### STAFF RECOMMENDATION 1602 17<sup>th</sup> Avenue South May 16, 2018

**Application:** New construction - outbuilding  
**District:** South Music Row Neighborhood Conservation Zoning Overlay  
**Council District:** 17  
**Map and Parcel Number:** 10408030200  
**Applicant:** Brittney Mount, Allard Ward Architects  
**Project Lead:** Melissa Sajid, [melissa.sajid@nashville.gov](mailto:melissa.sajid@nashville.gov)

**Description of Project:** Application is to construct a new structure in the rear yard. No changes to the historic building are proposed at this time.

# A0.1

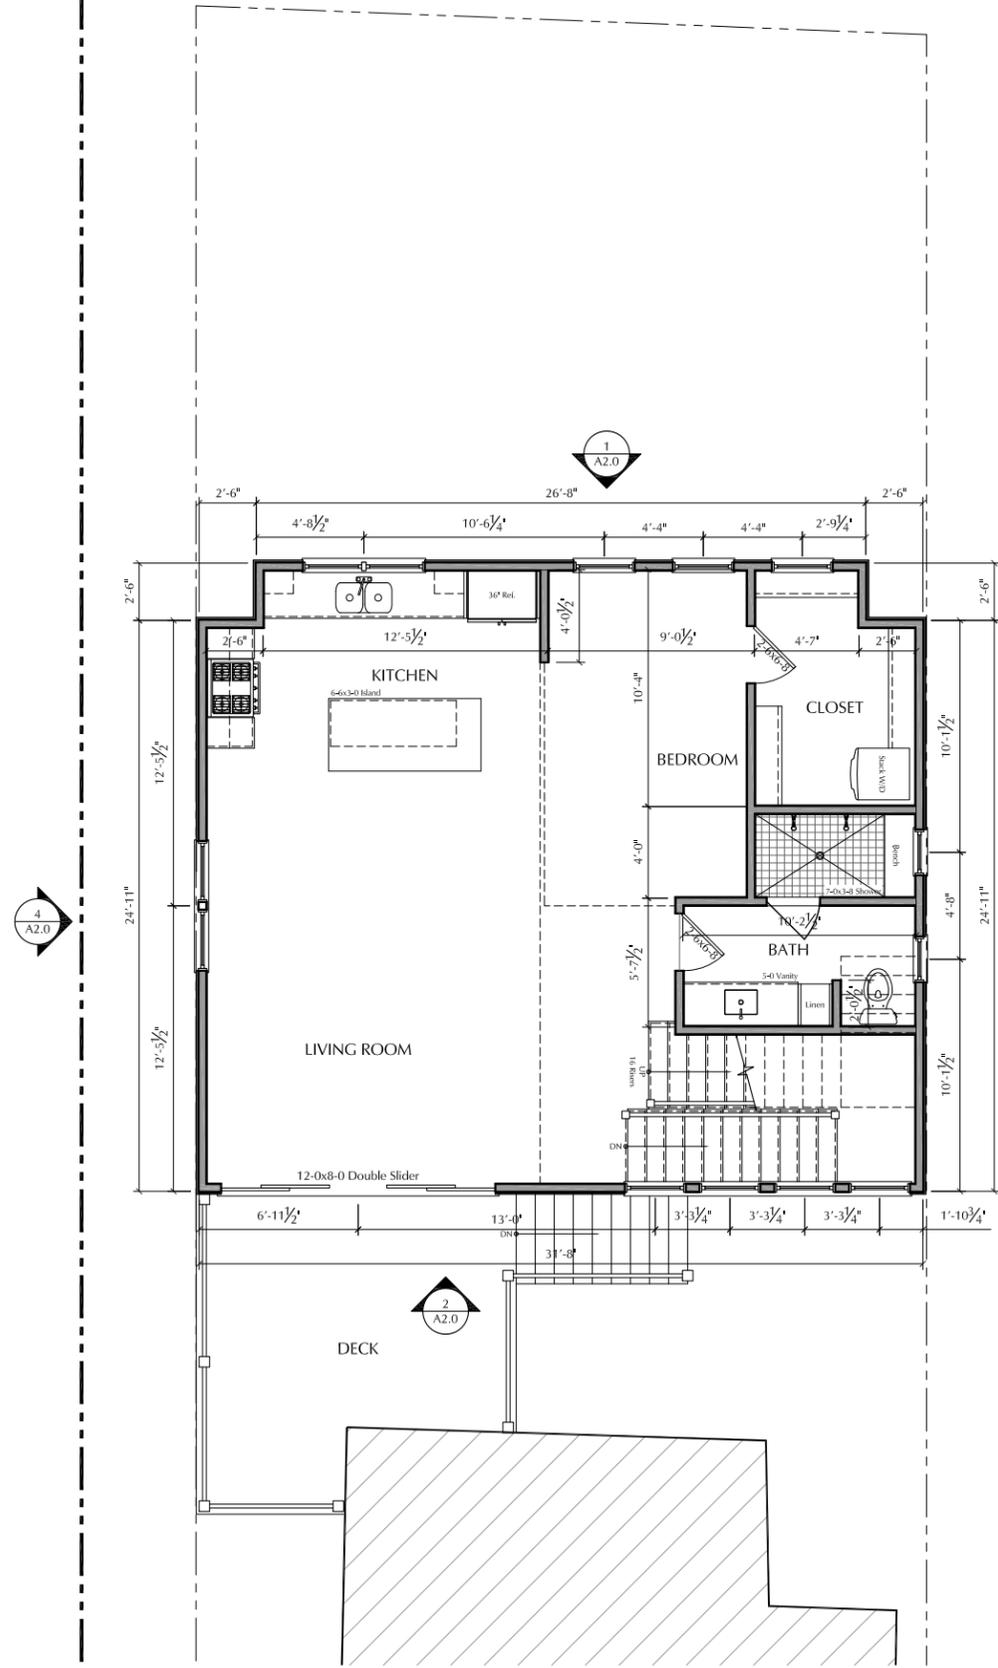
Location, Setback: The detached building will be located towards the middle of the lot with vehicular access and parking from the alley. The structure is located forty-six feet (46') from the rear property line, and five feet (5') from both side property lines; the building meets all setbacks per the Zoning Code. The front wall of the detached building is located approximately ten feet, six inches (10'-6") from the rear wall of the principle structure, but the two structures will be connected by an uncovered deck that will only be accessible from the new building. Although in most residential districts an outbuilding should have at least twenty-feet (20') between it and the principal building and an appropriate location is towards the rear of the lot, this location is appropriate for South Music Row because rear yards are not used for residential use but rather parking areas, as described previously. No changes to the openings of the historic building are proposed. Staff finds the uncovered deck to be appropriate in this case given its location, removability, and the surrounding context. Staff therefore finds that the proposed structure meets Section II.B.1.h.2. of the design guidelines.

**A2.0**

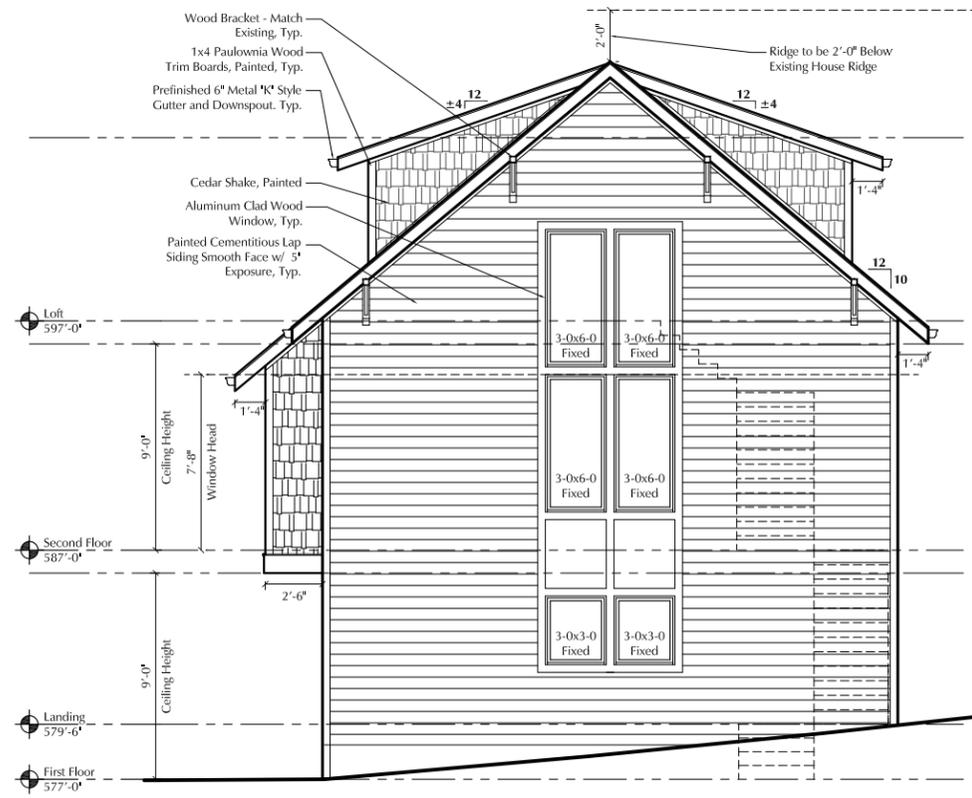
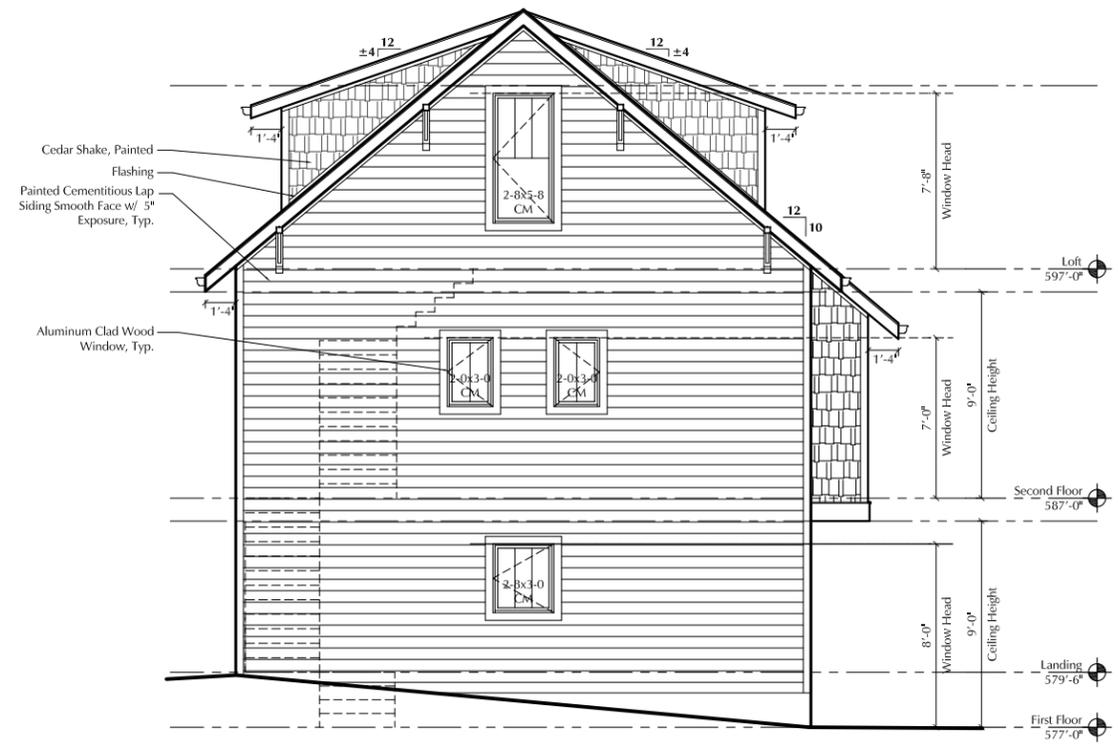
Design: The design of the detached building reflects the character of the historic house. The structure incorporates a side-gable as the primary roof form with a pitch that is similar to the historic house. The detached building mainly incorporates a traditional design with regard to the rhythm and proportion of openings but incorporates a modern interpretation for the window openings on the left side façade. Staff finds that the design is compatible with the historic house and that the project meets Section II.B.1.h.1.

**Materials, Roof Shape:** The roof will be side-gabled with a pitch that matches the historic house. The alley elevation includes a second story cantilevered bay, and shed dormers are featured on both the front and alley elevations. Both dormers set in two feet (2') from the wall below as required by the design guidelines.

The materials for the foundation, roof color, windows, pedestrian and vehicular doors, and deck material are unknown. Staff recommends that staff approve the final foundation, roof color, pedestrian and vehicular doors, and deck material selections prior to purchase and installation. With this condition, staff finds that the proposed materials can be consistent with the design guidelines and appropriate for the context, staff finds that, the project meets Section II. B.1.h.1.
